UNITED STATES
NUCLEAR REGULATORY COMMISSION
WASHINGTON, D. C. 20555

SUBJECT: ACCEPTANCE FOR REFERENCING OF LICENSING TOPICAL REPORT, EPRI
NP-2511-CCM, "VIPRE-01: A THERMAL-HYDRAULIC ANALYSIS CODE FOR
REACTOR CORES", VOLUMES 1, 2, 3 AND 4

Safety Evaluation Report on EPRI NP-2511-CCM VIPRE-01

Figure 5. MDNBR values calculated by VIPRE-01 and COBRA-IV for the Prairie Island locked rotor transient.

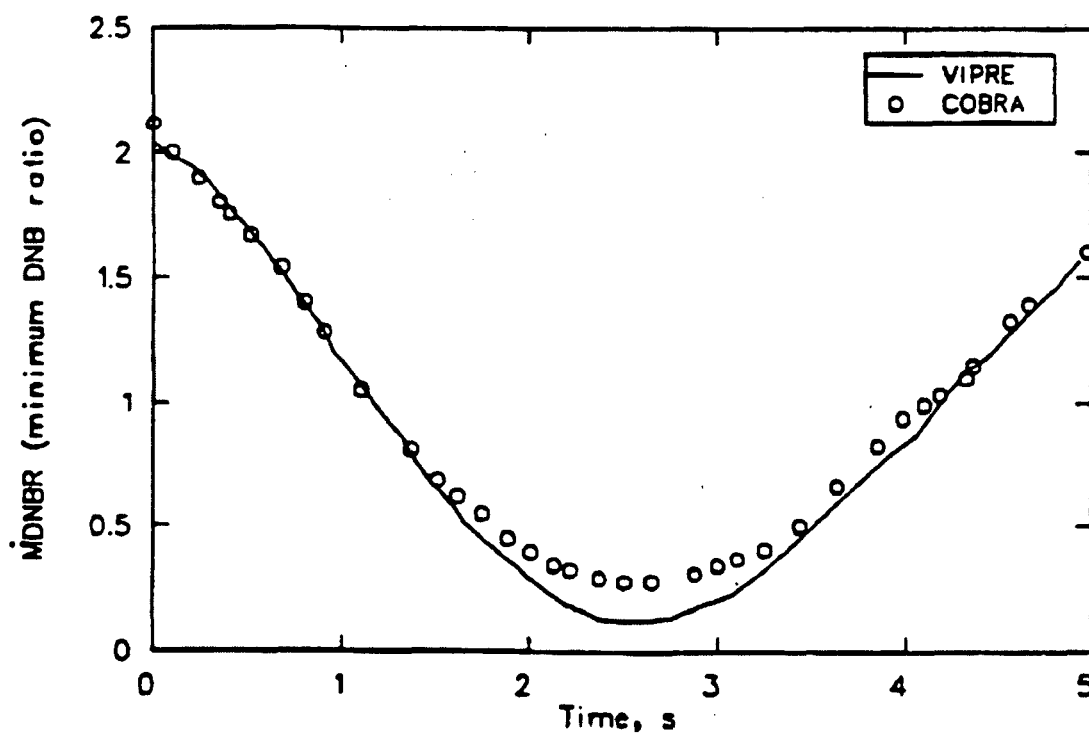
Minimum DNBRs calculated by the two codes during the transient are compared in Figure 5. The initial DNBRs agree within about 3.3% as discussed above. At approximately 0.5 seconds, however, the location of the Minimum DNBR calculated by both codes changed to another subchannel (VIPRE-01 subchannel 49 and COBRA-IV subchannel 4) which does not contain a control-guide tube.

Consequently, the cold-wall factor applied to the minimum DNBR by VIPRE-01 is 1.0 and the minimum DNBRs are in better agreement. This good agreement continues until about 1.5 seconds when the data begin to diverge with the VIPRE-01 data being more conservative. The divergence continues to about 2.5 seconds when a slow convergence is observed. The maximum difference in these minimum DNBR values, occurring at about 2.5 seconds, is 0.123 for VIPRE-01 compared to 0.278 for COBRA-IV.

The greatest difference in minimum DNBR, which occurred at about 2.5 seconds, is well after the DNBR of 1.0 was calculated and consequently is of no interest in either design or safety analyses. Based on the good comparison between these calculations for minimum DNBR ≥ 1.0 , it is concluded that the flow models and the RECIRC solution option used in the VIPRE-01 calculation are valid and properly implemented. It is concluded therefore that the RECIRC solution option is acceptable for licensing analyses.
